DEVELOPMENT REVIEW BOARD REPORT

CASE NUMBER/ PROJECT NAME	94-DR-2005 Windgate Crossing		
LOCATION	Northwest corner of Thompson Peak Parkway and Bell Road		
REQUEST	Request approval of a site plan and elevations for a mixed use retail/office center.		
OWNER	Windgate Crossing LLC/ Byxbee Development Partners 480-502-9720	ENGINEER	Hunter Engineering 480-991-3985
ARCHITECT/ DESIGNER	Butler Design Group LLC 602-957-1800	APPLICANT/ COORDINATOR	Charles Byxbee Byxbee Development Partners 480-502-9720
BACKGROUND	<p>Zoning.</p> <p>The property is zoned Central Business, Environmentally Sensitive Lands District (C-2 ESL). The C-2 ESL District is intended to allow commercial activities designed to serve the community while providing appropriate development for environmentally sensitive lands.</p> <p>Related References:</p> <p>Case 24-Z-1991 rezoned this property as part of an 800-acre master plan. Case 1-MP-2004 approved the Infrastructure and Environmental Design Master Plans for this master planned community</p> <p>Context.</p> <p>The 7.8-acre site is located at the northwest corner of E. Bell Road and N. Thompson Peak Parkway. Directly to the north and west is vacant State Land, and furthe

1 SITE PLAN
1" = 10'

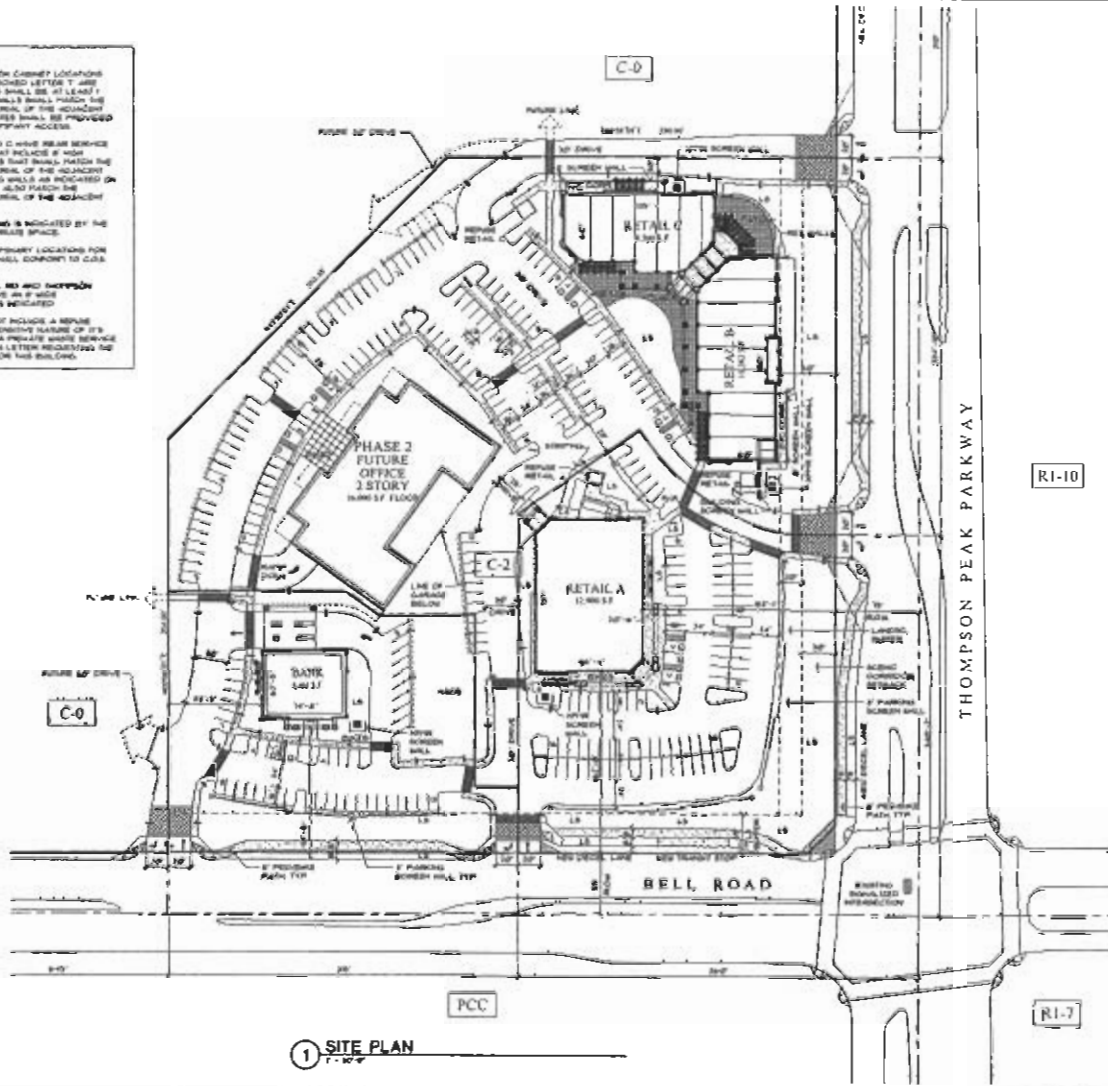
- b. *Demonstrate consistency with the approved master drainage report for the Windgate Ranch master planned community.*
 - c. *The preliminary grading and drainage plan shows underground detention via a number of underground tanks placed in series. The final drainage report will need to clearly illustrate the hydraulics in support of how the tanks provide detention and function both individually and as a whole. This requirement will include providing inflow and outflow hydrographs for each tank cluster and providing an outflow hydrograph for the outfall of the system.*

- d. *The preliminary grading and drainage plan shows the outfall for the on-site drainage system located across the state land remainder parcel. This outfall should be tied into the 54-inch public storm drain extension within the site if possible. If not tied in on-site, this outfall will require a private storm drain easement across the state land parcel.*

- e. *The preliminary grading and drainage plan shows the extension of the public 54-inch storm drain over the state land parcel. A public drainage easement will need to be provided over the state land parcel for the storm drain as a condition of plan approval.*

- 42. The developer shall provide a minimum of 120 feet of queuing distance for all "drive-thrus" (Bank, fast-food, etc.).
- 43. *The developer shall provide directional handicap ramps at all driveways.*

- 44. *Cross access easements shall be provided at both driveway entries shared with the state land remainder parcel. Evidence of recorded access easements will need to be provided to approve final plans.*

- 45. *The developer will need to illustrate how adequate access to the adjacent state land remainder parcel for the western driveway will be provided. The access will need to take into account the anticipated use of the driveway connection based on the anticipated future development of the state land remainder parcel to the satisfaction of final plans staff.*

- 46. *Final plans shall clearly show signing and striping for the drive through for building A. The configuration of the signing and striping and the location and configuration of the drive through will need to provide adequate queueing distance for cars using the drive through and provide adequate separation from the adjacent passing lane.*

Conceptual Landscape Plan

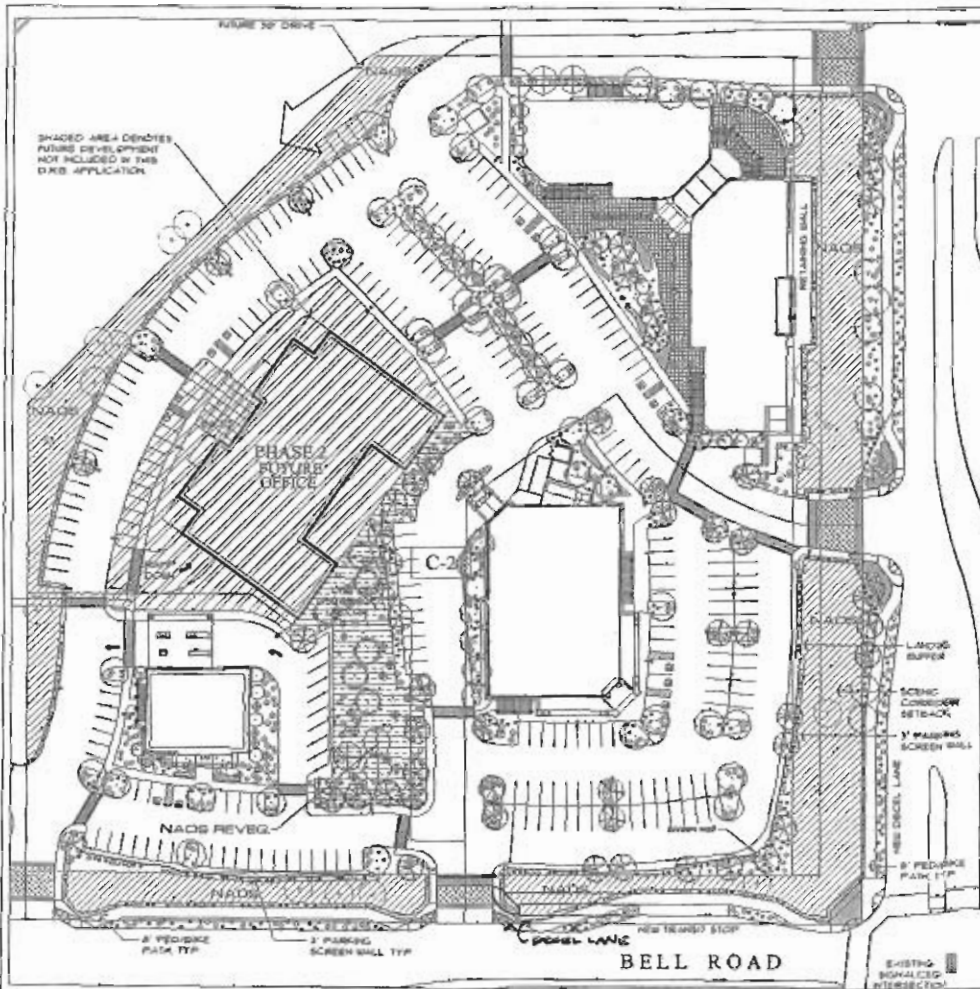
22. *The landscape palette shall be revised to include only plant species selected from the Environmentally Sensitive Lands indigenous plant list and Arizona Department of Water Resources low water use/drought tolerant plants "PHX" list.*
23. *Landscape pots (36-inch diameter minimum and irrigated) and/or raised landscape planters and benches shall be provided in plaza areas, and in areas along the east and south sides of the drugstore building (Retail A).*
24. *At time of final plans the landscape plans shall be revised to show landscape between the parking lot and the trellis feature along the east elevation of the drugstore building (Retail A).*
25. *Upon removal of the salvageable native plants the salvage contractor shall submit completed Native Plant Tracking Form as well as a list identifying the tag numbers of the plants surviving salvage operations to*

C. Landscape palette shall be revised to comply with the *Environmentally Sensitive Ordinance*.

D. Landscape areas in decomposed granite or similar material shall not exceed more than seven (7) feet in any one (1) direction as measured between plants or plant canopies.

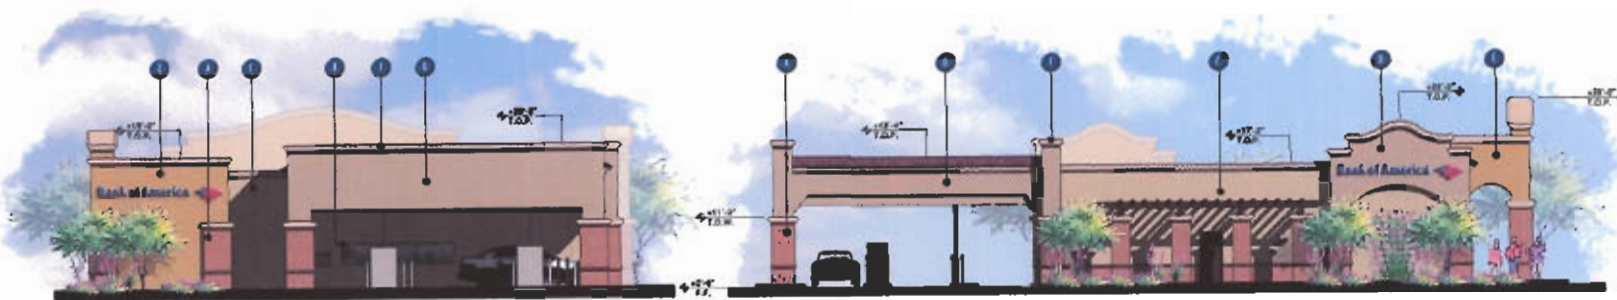
The relationship between the architectural design of the drugstore building (Retail A) and the shape and bulk of the drive through canopy.

2. *The drugstore building (Retail A) elevations shall be revised to provide a trellis along the Bell Road and Thompson Peak Parkway elevations to extend from the arcade to the end of the building.*

5. *Pneumatic tube delivery system for all drive through facilities shall be either located underground, or integrated into the architecture of the drive through canopy. No exposed tube systems shall be allowed.*
